Appendix A

**Better Market Street Final Section 4(f) Evaluation**

Figure 1: Transit stop comparison. (Source: DEIR App. 11—*Better Market Street Final Report*, 2013; pp 18-19.)

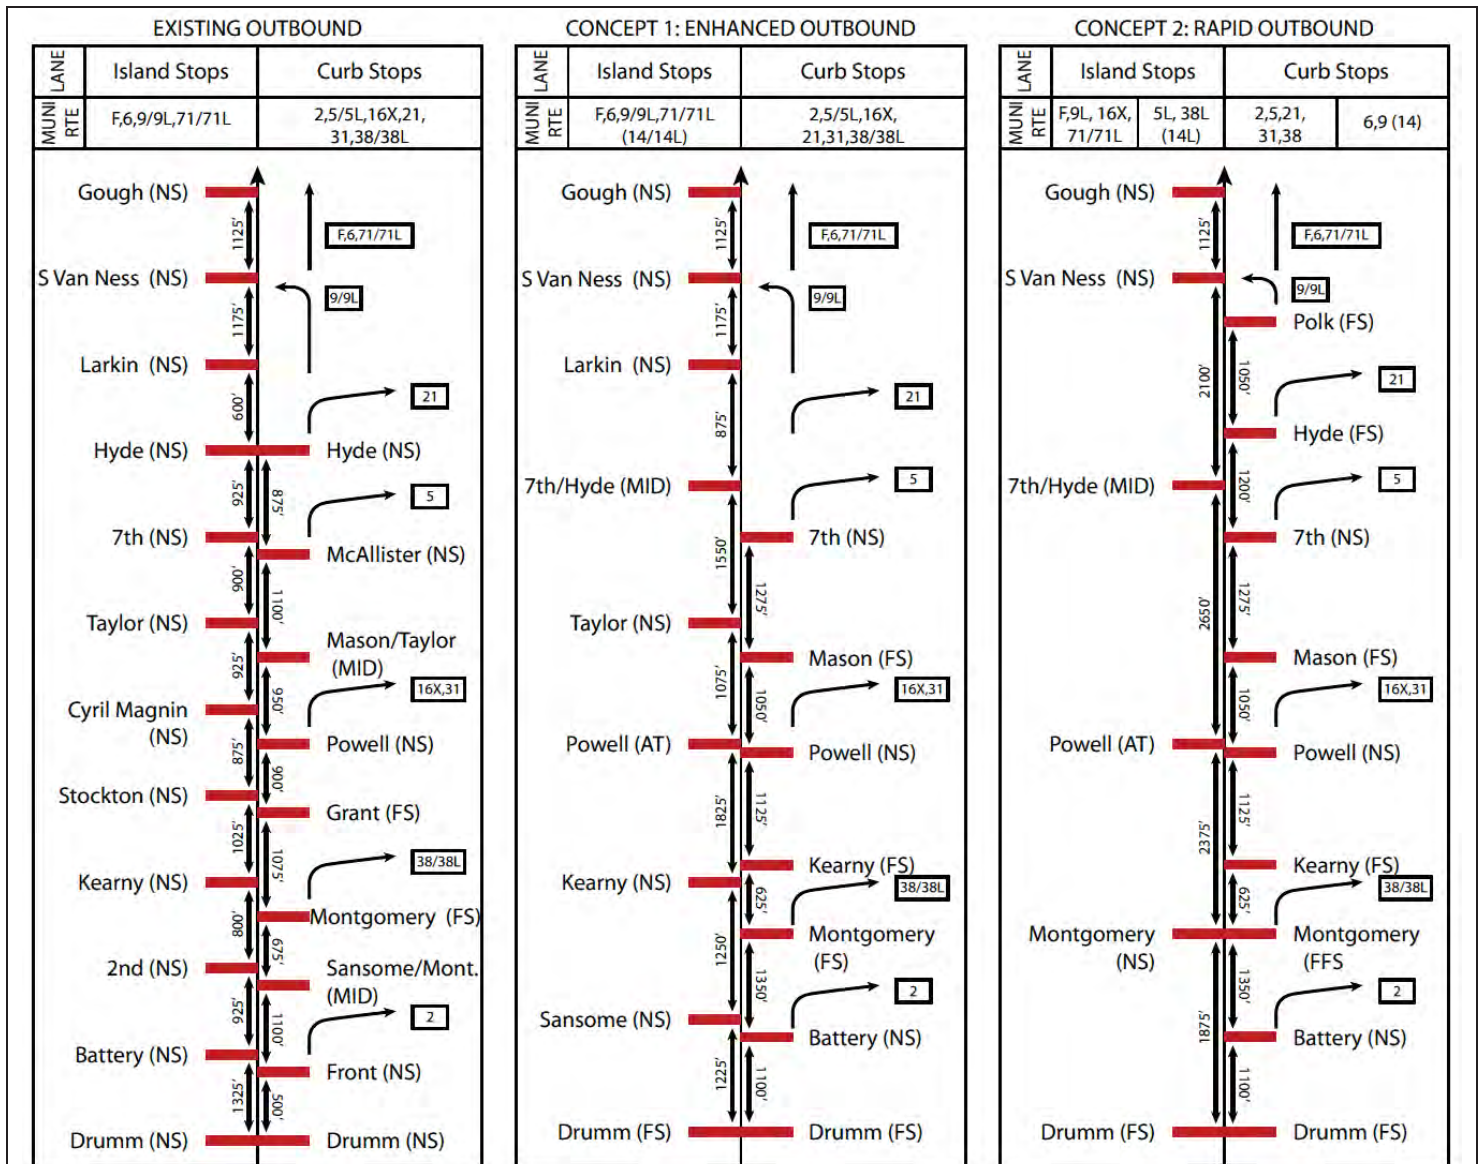
A close examination of the staff proposals show that Muni is squeezed at Fourth Street between BART entry structures and the proposed surface bikeways in a manner that appears to give lowest priority to providing an island Muni stop at this and possibly other locations. This raises questions as to the design of
